2 Type of change

New Configuration Code or change of Configuration Code

Product Change Notification					PCN for PG06 (Change Config.Code)		
owner	creation date	release date	released by	change order no	rev	page	D10-025-322
hollenpe	09.05.2018	05.07.2018	limachcl	2015365	A	1 of 2

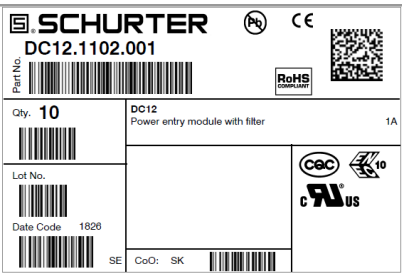
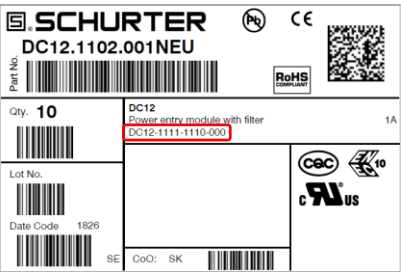
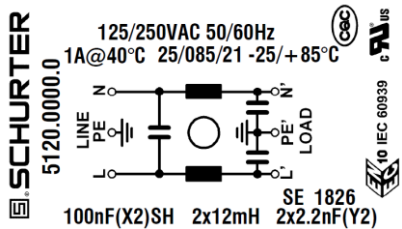
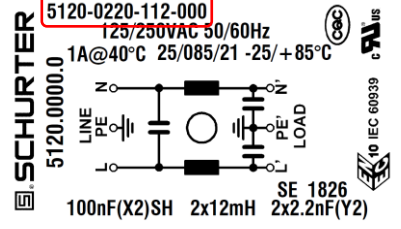
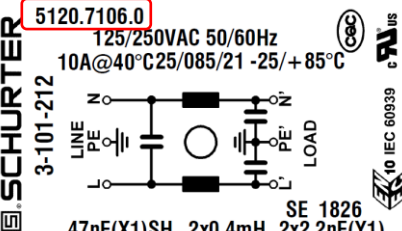
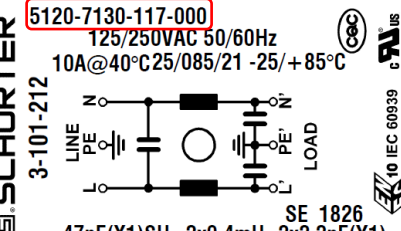
The configuration code has been modified. This change affects all the configuration codes depicted in documents by SCHURTER AG which refer to the affected products. This includes the packaging label and documents created in SAP(e.g. invoices, order papers, etc.). None of the part numbers will be altered and will remain the same as before. To secure a unique reference, SCHURTER asks the customer to refer to the part number for future correspondence. The configuration code can be used as a second reference to identify the technical properties of a product. Please check the list "Change of configuration code PG05_06_07" for a reference of the old and new configuration code with the according part number. You can find said list in the SCHURTER Partner Service on our website.

Old packaging label (without old CC)	New packaging label (with new CC)
 <p>Part No. DC12.1102.001 Qty. 10 DC12 Power entry module with filter 1A Date Code 1826 SE CoO: SK</p>	 <p>Part No. DC12.1102.001NEU Qty. 10 DC12 Power entry module with filter 1A DC12-1111-1110-000 Date Code 1826 SE CoO: SK</p>
Old product label (without old CC)	New product label (with new CC)
 <p>5120.0000.0 125/250VAC 50/60Hz 1A@40°C 25/085/21 -25/+85°C 100nF(X2)SH 2x12mH 2x2.2nF(Y2) SE 1826</p>	 <p>5120-0220-112-000 125/250VAC 50/60Hz 1A@40°C 25/085/21 -25/+85°C 100nF(X2)SH 2x12mH 2x2.2nF(Y2) SE 1826</p>
Old product label (with old CC)	New product label (with new CC)
 <p>5120.7106.0 3-101-212 125/250VAC 50/60Hz 10A@40°C 25/085/21 -25/+85°C 47nF(X1)SH 2x0.4mH 2x2.2nF(Y1) SE 1826</p>	 <p>5120-7130-117-000 3-101-212 125/250VAC 50/60Hz 10A@40°C 25/085/21 -25/+85°C 47nF(X1)SH 2x0.4mH 2x2.2nF(Y1) SE 1826</p>
